IEC
60099-4

AMENDMENT 1
2006-05

Surge arresters –

Metal-oxide surge arresters without gaps for a.c. systems

Figure 13 – Examples of arrester units

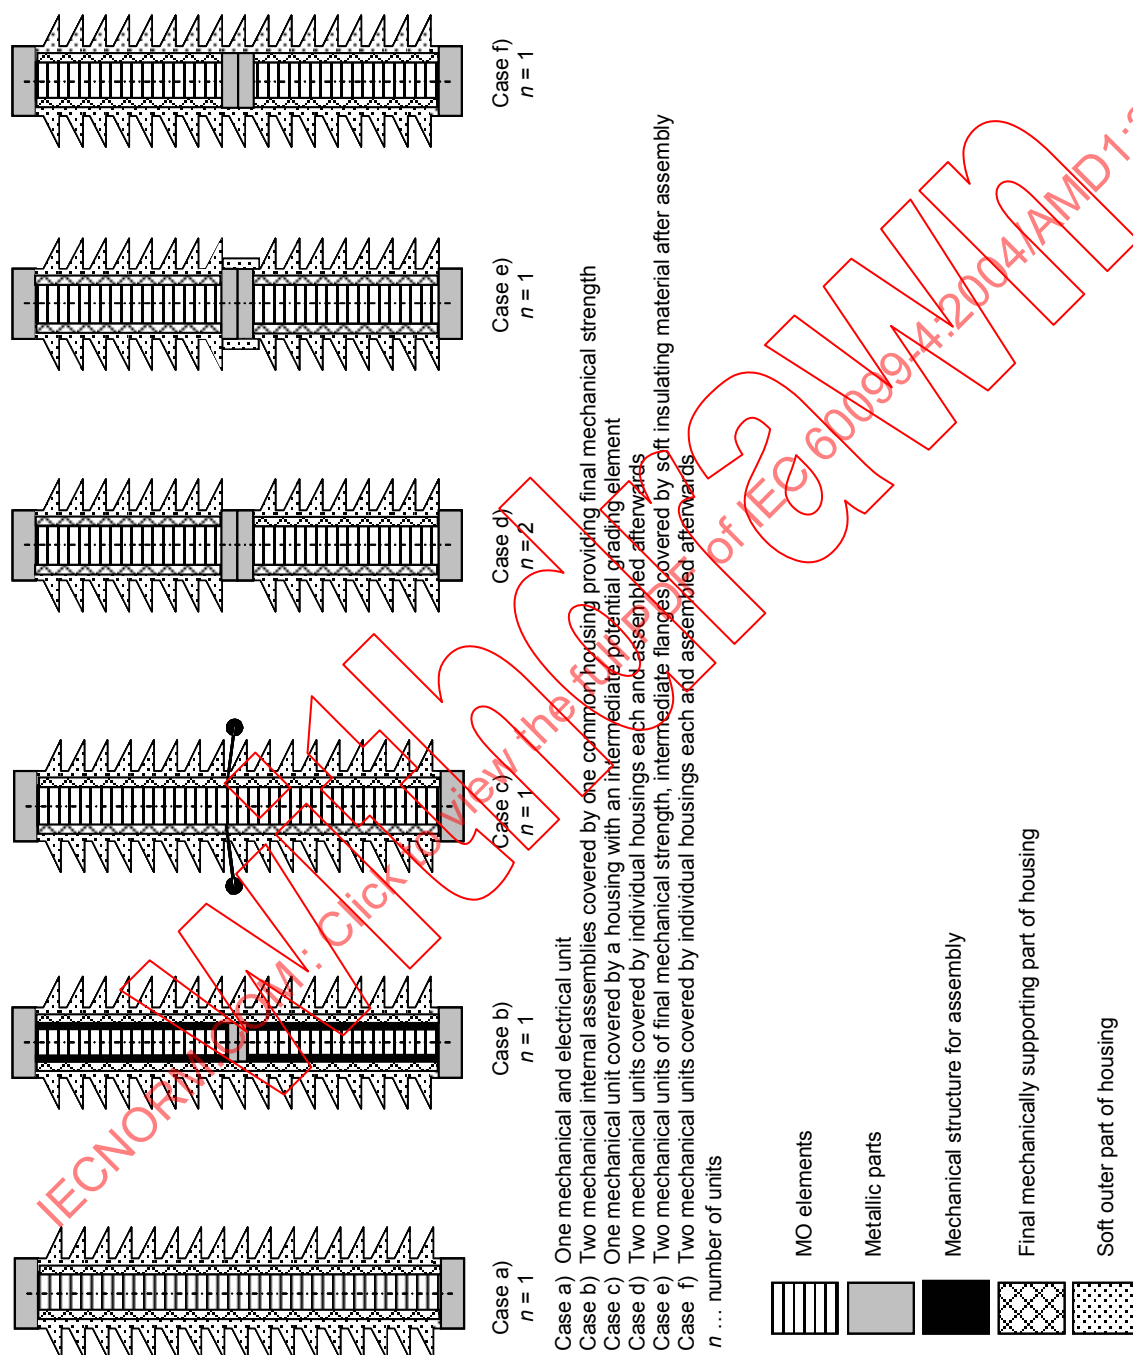
Figure 13 – Examples of arrester units

NOTE 1 Figure 13 shows different examples of arrester units.

For the high-current tests, the test samples shall be the longest arrester unit used for the design with the highest rated voltage of that unit used for each different arrester design.

For the low-current test, the test sample shall be an arrester unit of any length with the highest rated voltage of that unit used for each different arrester design.

Figure 14 – Short-circuit test setup

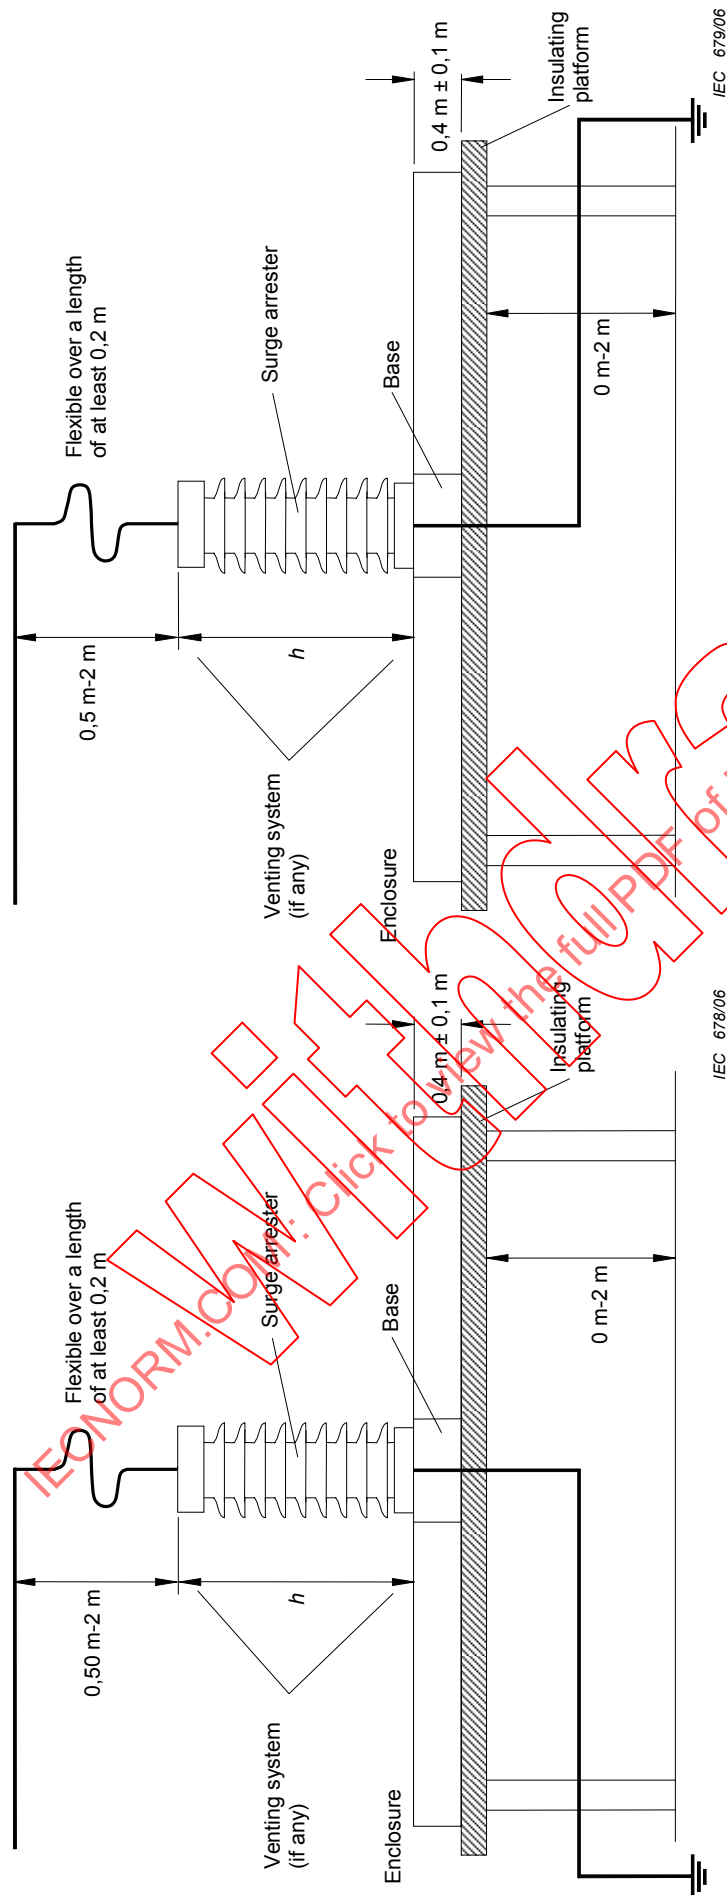
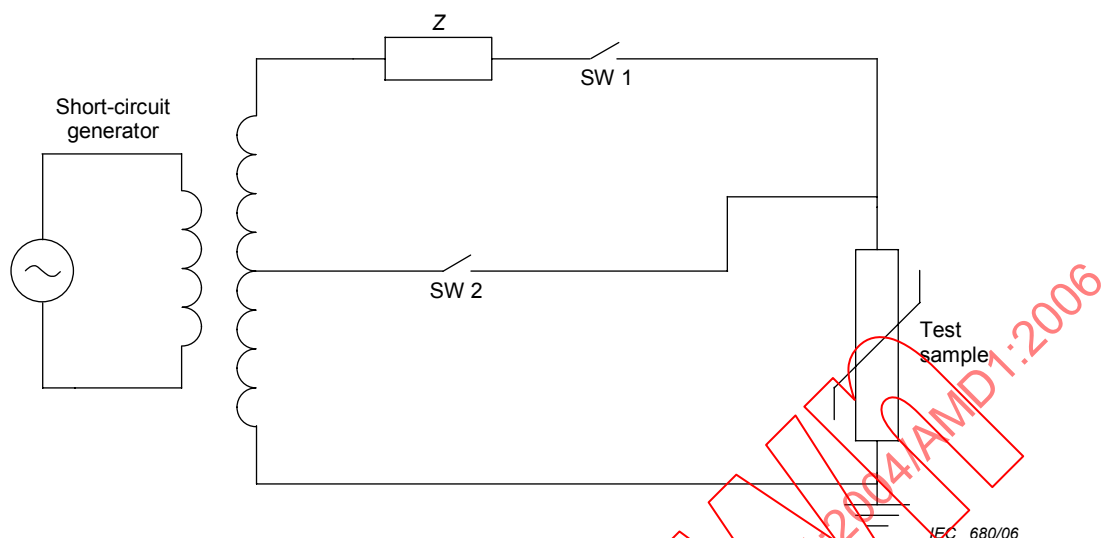
Figure 14 – Short-circuit test setup

For a base-mounted arrester, the mounting arrangement is shown in Figures 14a and 14b. The distance to the ground from the insulating platform and the conductors shall be as indicated in Figures 14a and 14b.

Porcelain-housed arresters shall be mounted according to Figure 14a. Polymer housed arresters shall be mounted according to Figure 14b.

The routing shown in Figure 14a is the most unfavourable to use during the initial phase of the test before venting occurs (especially in the case of a surge arrester fitted with a pressure relief device). Positioning the sample as shown in Figure 14a, with the venting ports facing in the direction of the test source, may cause the external arc to be swept in closer proximity to the arrester housing than otherwise. As a result, a thermal shock effect may cause excessive chipping and shattering of porcelain weather sheds, as compared to the other possible orientations of the venting ports. However, during the remaining arcing time, this routing forces the arc to move away from the arrester, and thus reduces the risk of the arrester catching fire. Both the initial phase of the test as well as the part with risk of catching fire are important, especially for arresters where the external part of the housing is made of polymeric material.

For all polymer-housed arresters, the ground conductor should be directed to the opposite direction as the incoming conductor, as described in Figure 14b. In this way, the arc will stay close to the arrester during the entire duration of the short-circuit current, thus creating the most unfavourable conditions with regards to the fire hazard.

Replace, in the second sentence of the fourth paragraph, Figures N.2 and N.3 by Figures 14a and 14b.

Replace, in the second sentence of the NOTE, Figure N.2 by Figure 14a.

Replace, in the next to last sentence of the NOTE, Figure N.3 by Figure 14b.
